APPENDIX F

Correspondence with the Authority

Project Title: Mai Po Nature Reserve Infrastructure Upgrade Project
(EIA Study Brief No. ESB-301/2017)

**EIA Study for Mai Po Nature Reserve Infrastructure Upgrade Project (ESB-301/2017)
Revised Proposal for Noise Impact Assessment for Agreement**

Figure 1 Components of the Project Currently Proposed

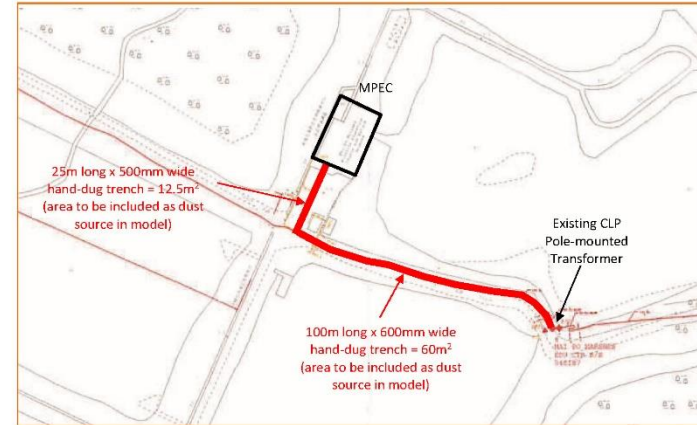
- (i) **Figure 1**, attached, shows the components of Project as currently proposed and can be compared directly with **Figure 2**, which is Figure 1-2 from the Project Profile – both are at the same scale. It is not considered necessary at present to upgrade the bunds for use as temporary haul roads, but if this does prove necessary, then the impacts of such upgrading works will be included in the EIA.

(v) In the Project Profile, widening of the footpath up to 3.3m was mentioned – this was for the EAs, although these were not mentioned by name – and was based on the conceptual layout of the footpath at that time. While no specific locations were identified in the Project Profile, as the design of the Project has evolved 6 no. locations for EAs have been identified, as shown in **Figure 1**. The EAs range from 1.0m to 3.5m wider than the 1.65m boardwalk.

Based on the information provided, we are pleased to confirm that the scope of issues covered by the above EIA Study Brief can still cover the changes as stated in the above letter.

Figure 1-1 Locations of Representative NSRs

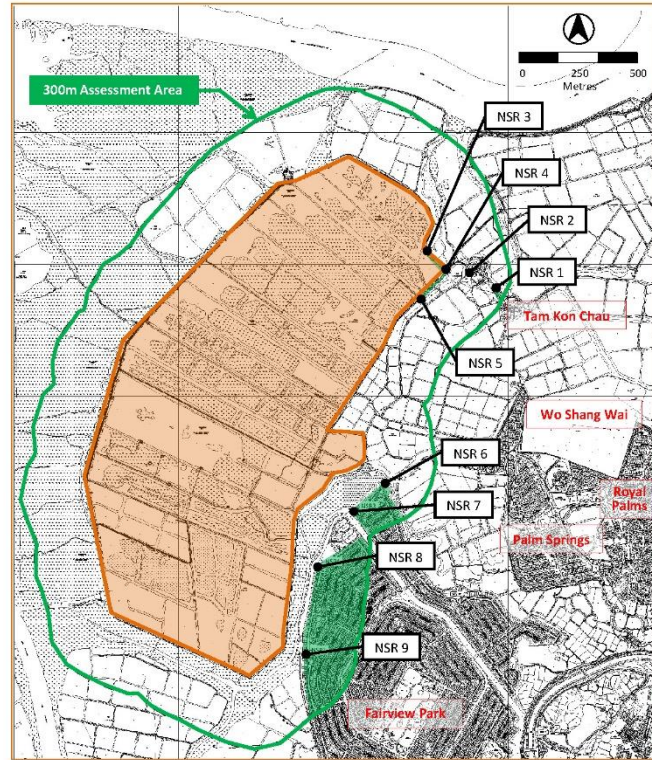
The assessment area proposed for the construction noise impact assessment shall generally include areas within 300 metres from the boundary of the Project and the works of the Project. *Figure 1-1* shows boundary of the Project Site and the proposed 300m Assessment Area for the agreement of the Director.

All existing Noise Sensitive Receivers (NSRs) are shown in *Figure 1-1* and comprise all residential uses within 300m of the Project boundary. However, only the first-tier, closest, NSRs have been identified as representative NSRs for the purpose of assessment, for the agreement of the Director. These are summarised in *Table 1-1* and their locations are shown in *Figure 1-1*. Photographs of the representative NSRs showing the Noise Assessment Points (NAPs) are provided as *Annex 1* to this Proposal and shall also be provided in the EIA Report.

Based on the information provided, the assessment area, assessment points and representative phases of construction that would have noticeable varying construction noise emissions at existing noise sensitive receivers for construction noise impact assessment are hereby agreed pursuant to clauses 2.2.1(a), 2.2.1(c) and 2.3.1, Appendix B of the EIA Study Brief No. ESB-301/2017.

Figure 3-3 Programme and Representative Phases of Construction

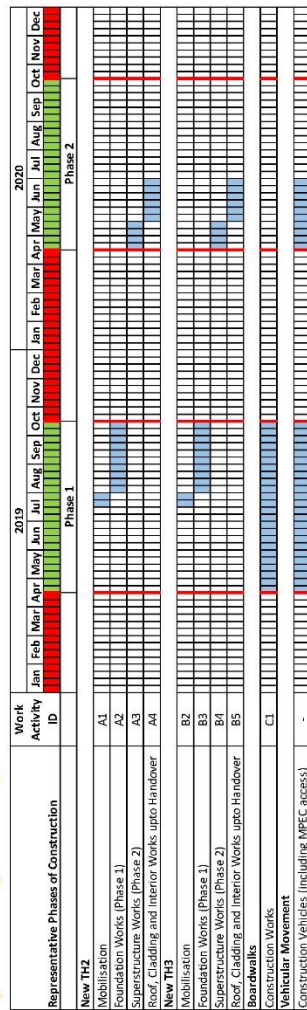
The current Project Programme is shown in [Figure 3-3](#), which shows the representative phases of construction (in fact, the entire construction phase) for the agreement of the Director. Note the periods shown in red when no noisy outdoor construction work other than mobilisation and vehicle movement shall be permitted.

Figure 3-5a Layout Plan Showing Construction Working Phases for New TH2 (Indicative)

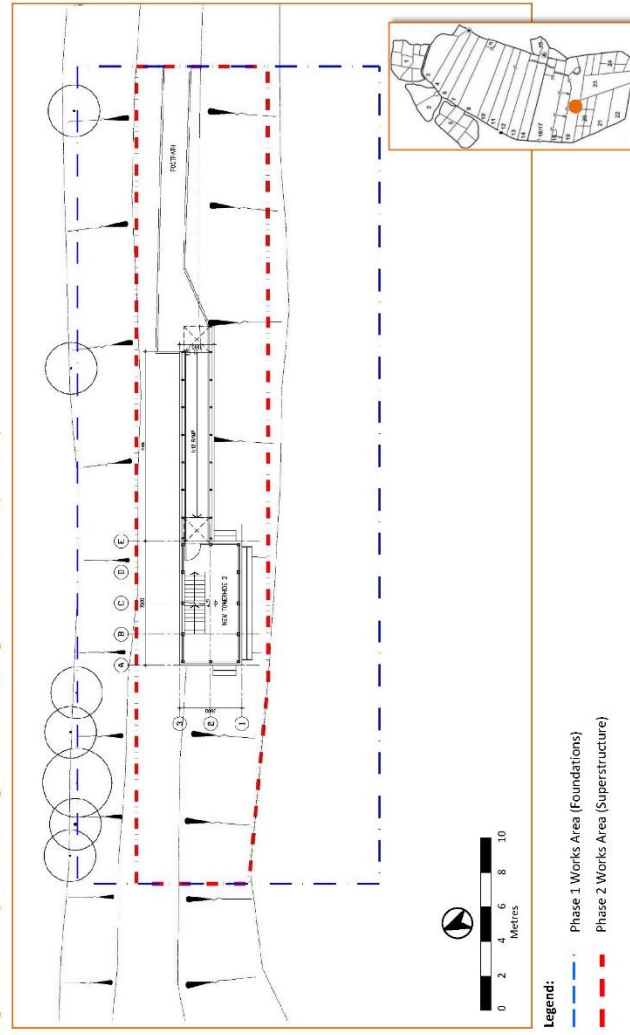
A layout plan showing construction working phases of the Project is provided in [Figure 3-5a to c](#). Note that construction of the new tower hides has been split into foundation works (Phase 1) with a larger site area, and superstructure works (Phase 2) with a smaller site area. Construction of the new boardwalks will be carried out sequentially in 100m lengths during Phase 1 only.
